Access Compliance Report

Public Rights-of-Way

(Curb Ramps)

Intersection ID: 47645	Main Street: ALDWYCH_WY	Cross Street: WESTON_WOODS_LN	Location: NE
ADA ID: BB3E0DC424B2	Ramp Type: PerpDiag	Initial Pass/Fail: Fail	Overall Compliance: No
		Severity Score: 13.75

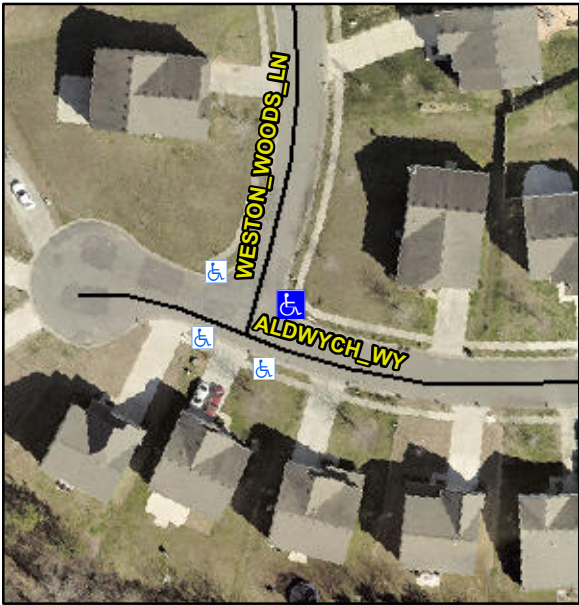
Codes/Mitigation Info/Possible Solution			Field Measurements/Component Compliance					
	Possible Solutions:		Compliance	Description	Data	Compliance	Description	Data
	Remove & Replace Curb Ramp With Two New Directional Ramps or Equivalent.		N/A	Ramp Length (in)	47.0	No	Ramp Slope (%)	8.8
			Yes	Ramp Width (in)	48.0	No	Ramp XSlope (%)	2.4
			N/A	Flare Type LT	N/A	N/A	Flare Type RT	N/A
			N/A	Flare Slope LT (%)	N/A	N/A	Flare Slope RT (%)	N/A
			N/A	Flare Traversable LT?	N/A	N/A	Flare Traversable RT?	N/A
			N/A	Landing Length (in)	N/A	N/A	DWS Provided?	N/A
			N/A	Landing Width (in)	N/A	N/A	DWS Contrast?	N/A
			N/A	Landing Slope (%)	N/A	N/A	DWS Length (in)	N/A
			N/A	Landing X Slope (%)	N/A	N/A	DWS Full Width?	N/A
Surveyor Notes:		N/A	N/A	Landing Curb? (Y/N)	N/A	N/A	DWS Offset (in)	N/A
PROW/ADA:		Not Found, R304.2.2, R304.5.3	N/A	Shared Landing?	N/A			
			N/A	Gutter Ponding?	N/A	N/A	Gutter Slope (%)	N/A
			N/A	Gutter Lip Ht (in)	N/A	N/A	Gutter X Slope (%)	N/A

N/A	Painted X Walk1?	No	N/A	Painted X Walk2?	No
				X Walk 1 Direction	To NW		X Walk 2 Direction	To SW
			N/A	X Walk 1 Width (in)	N/A	N/A	X Walk 2 Width (in)	N/A
				X Walk 1 Slope (%)	1.3		X Walk 2 Slope (%)	0.2
				X Walk 1 X Slope (%)	0.8		X Walk 2 X Slope (%)	3.0
			N/A	Ramp inside XWalk1?	N/A	N/A	Ramp inside XWalk2?	N/A
				Road Slope (%)	2.1	N/A	Clear Space?	N/A
				Road X Slope (%)	1.5	N/A	Clear Space to XWalk (in)	N/A
			N/A	Any Obstructions?	N/A	N/A	Storm Grate/Utility Hazard?	N/A
				Obstruction Type			Storm Grate/Utility Type	
					N/A			N/A
						Yes	Surface Condition? (G/P)	Good
Street 1 Name		WESTON WOODS LN						
Stop Condition-Street 2		StopSign						
Street 2 Name		ALDWYCH WY						
Stop Condition-Street 1		None						
Total Cost:		\$ 3200.00
